# **LANDOWNER SUBMISSION REVIEW**

**PRCUTS Stage 1**

**Canada Bay Council has engaged GroupGSA to undertake an independent urban design assessment of various proposals submitted by land-owners impacted by the Stage One Parramatta Road Corridor Precincts project.**

Current Master Plan controls for Lot B4

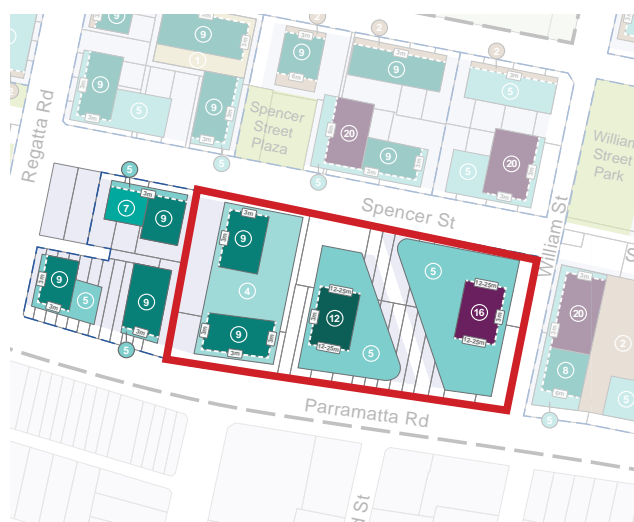
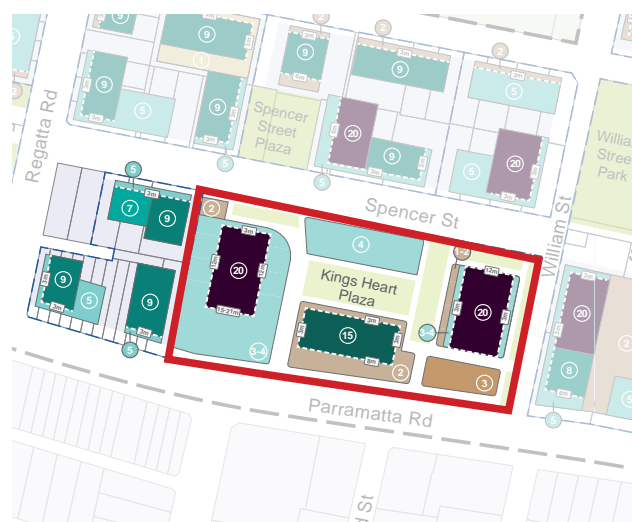
The proposal is consistent with the current FSR/density requirements as outlined in the Stage One Kings Bay Master Plan, but increases the site's overall yield and building footprint. Also, overshadowing of Spencer Street, William Street, the proposed road reserve, and built form within Lot B3 to the site's west is significantly increased with the proposed tower form.

67m building height is applied to the Western and Eastern towers on William Street and proposed through site street interface. The location of the four storey podium topped with a 20 storey tower against the western boundary does not achieve adequate sunlight access and does not provide sufficient communal open space between buildings.

The three proposed consolidated towers and increase of overall building heights within the site will lead to further overshadowing of Spencer Street, William Street, the proposed road reserve, and built form within Lot B3 during active morning hours.

- The proposed alternative built form and layout is supported, pending implementation of the revised Master plan built form.
- The central mid-block along Spencer St. should be removed and floor space allocated to the residential towers. This will increase feasibility and activate Spencer Street by providing a public space that is connected and contiguous with Spencer Street.

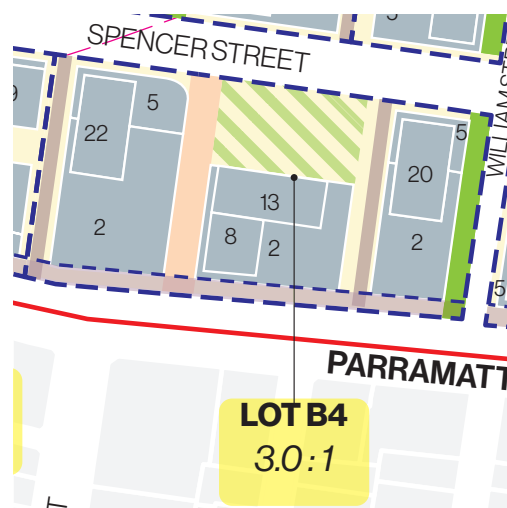
The scheme does not demonstrate solar compliance to ADG. Overshadowing and any potential increases to overshadowing should be minimised or avoided.

The mid-block facing Spencer Street will create a plaza that is internal to the development and physically disconnected from Spencer Street. This will create a confusing hierarchy of public spaces and reduce activation of Spencer Street. Activation of Spencer Street is a priority of PRCUTS and of the desired future character for the precinct.

Current master plan for Lot A3, with easement (red)

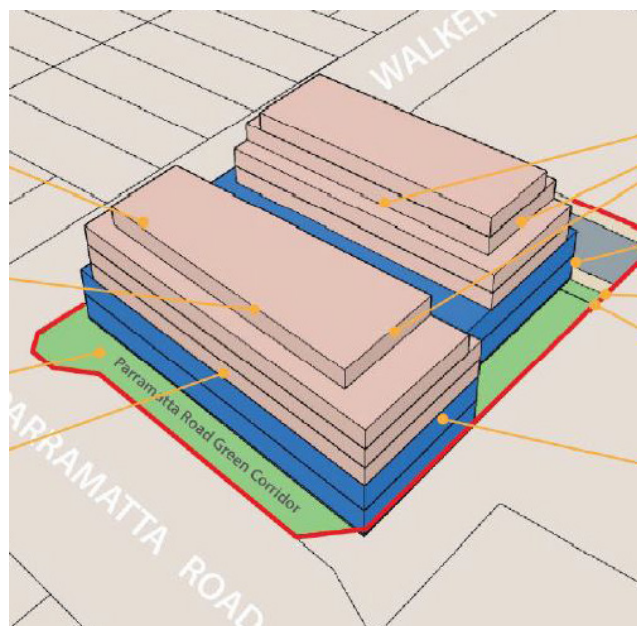
The submission furthermore proposes that the permissible FSR for Lot A3 should be increased from 1.6:1 to 2.2:1 as was proposed in the *PRCUTS Planning and Design Guidelines*, alongside a proposed height increase of one storey, to a maximum building height of 21m or six storeys.

The submission's proposed envelope suggests two storeys of commercial land use, in opposition to the planning proposal's controls for the R3 zone, which allows only a single storey of commercial at ground level.

The proposed two storeys of commercial premises sought in the submission is not supported, and is not consistent with the R3 zone planning controls, which allow only one storey of commercial fronting along Parramatta Road. The Stage One Kings Bay Master includes only one storey commercial.

- The 3m setback along Spencer Street is to be maintained, to ensure a consistent street-wall along the Road Reserve, and to maintain its character as a residential frontage and pedestrian boulevard with space for planting.

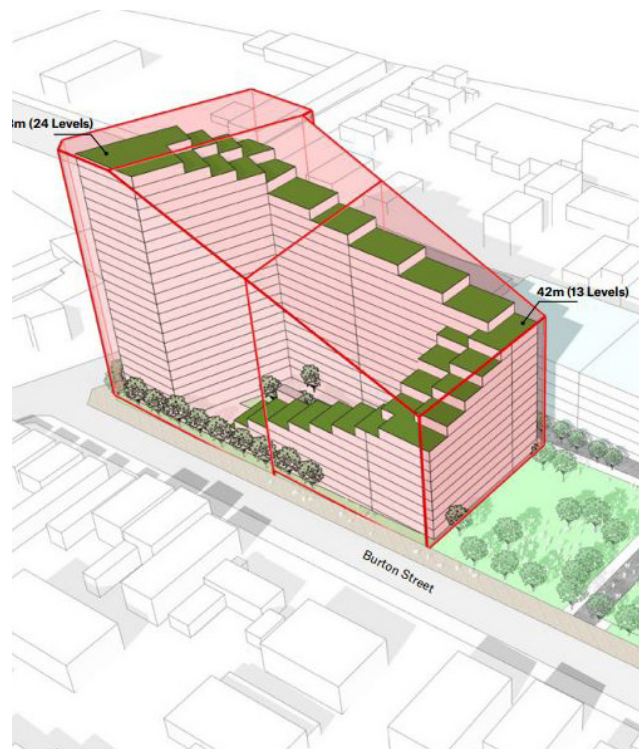
The typology of built form within the Residential Nexus is comprised of two storey podiums topped with a series of towers of reducing heights. The current proposal as outlined in the Stage One Burwood-Concord Master Plan features two buildings of this typology which increase in height towards Loftus Street and Concord Oval.

Furthermore the continuous multi-storey street-wall interface negates the maximum building height level change from a pedestrian perspective, as the unbroken form would lead to overshadowing of the public domain regardless of height.

Heights are utilised within the ADG to minimise site coverage and to provide generous separation between buildings. By producing a singular built form without separation on-site, the submission significantly reduces the permeability of the surrounding streetscape. The continuous wrap-around built form is also unlikely to be able to be ADG compliant, including for cross-ventilation and solar access requirements.

Overshadowing of the proposed road reserve and of the Metro Station site to the south is significantly increased by merging the two separate towers proposed for Lot B2. By ignoring the building separation recommended by the Stage One Master Plan, the Metro Station site to the immediate south are denied access to northerly views and midday natural lighting.

- Relocation of the park is supported pending compliance with the built form controls for the remainder of the site recommended in the revised master plan to ensure the outcomes are acceptable in terms of overshadowing, pedestrian and traffic movement, public domain activation, and building envelope. Relocation of the park will enable creation of a more activated public space that is closely integrated with the future Metro entryway.

- The built form and density proposed is unacceptable due to a poor urban design response, overshadowing of adjoining properties and a poor pedestrian interface, as a result of excessive building scale and length. The 4.5:1 FSR is not consistent with the PRCUTS Planning and Design Guideline and the proposed single building mass will result in an excessive bulk and scale that is unlikely to be able to be ADG compliant.

- Additional DCP controls will also be required to be implemented to ensure that the final built form achieves an acceptable urban design response, including building separation, civic space, and through-links.

Indicative impact area on current Master Plan - Kings Bay Precinct

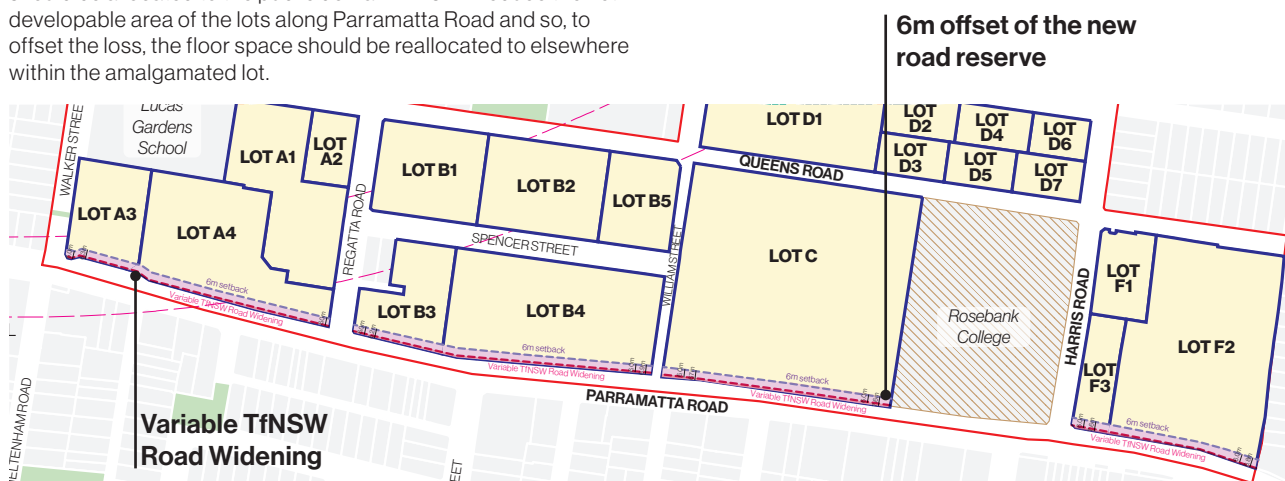
Reduction of public domain along the northern road reserve would have significant impact on the future character of Parramatta Road as a green and activated street with prioritised pedestrian linkages and strong relationships to building frontages, in particular, the new Metro West Station.

The current Master Plan recommends a continuous active frontage along the northern road reserve in line with PRCUTS Planning and Design Guidelines and to strengthen the mixed-use role of Parramatta Road. Therefore, to achieve the vision, whilst accommodating the requested wider road reserve, more land should be allocated to the public domain. This will reduce the net developable area of the lots along Parramatta Road and so, to offset the loss, the floor space should be reallocated to elsewhere within the amalgamated lot.

This will also require some amendments to the built form to ensure there are no adverse impacts on the surrounding area, including most importantly that any increases in building height do not create overshadowing of the south side of Parramatta Road. This review tested the reallocation of floor space with a benchmark as per ADG requirements.

- Maintain the 6m wide public domain along Parramatta Road to ensure a consistent streetscape and walkable environment; and increase the width of the Parramatta Road corridor to accommodate the Agency's intention for a future dedicated bus lane.

- Where the additional floor space that will need to be reallocated cannot be redistributed on a development lot due to overshadowing impacts or ADG compliance, the maximum FSR/building heights may need to be reduced. This peer-review tested the implications of implementing the wider road reserve with the subject floor space reallocated within the amalgamated lots. The revised Master plan recommends some adjustments to the maximum heights and FSRs that achieve maximum development yields and ADG compliance, including the solar access requirements.

Indicative impact area on current Master Plan - Burwood Precinct

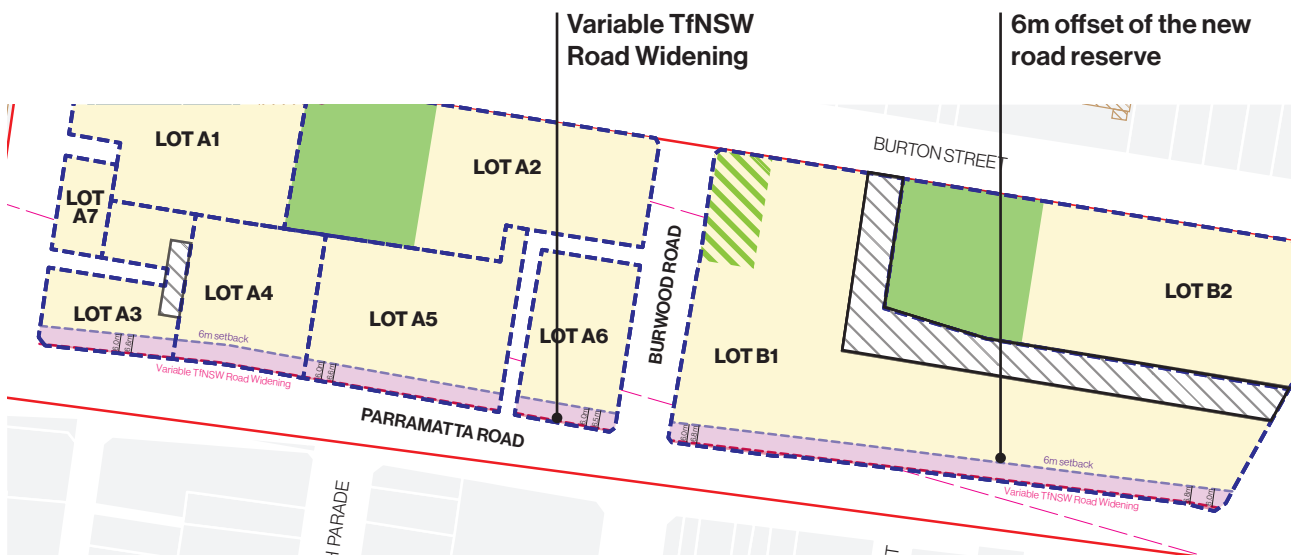
The proposed interventions identified in the submission will also require updates to draft Public Domain Plan and Infrastructure Strategy.

- Update Burwood-Concord Master Plan to include the latest information from Metro project team. Burwood North Metro will be located on both sides of Parramatta Road with pedestrian and cyclist link under Parramatta Road.
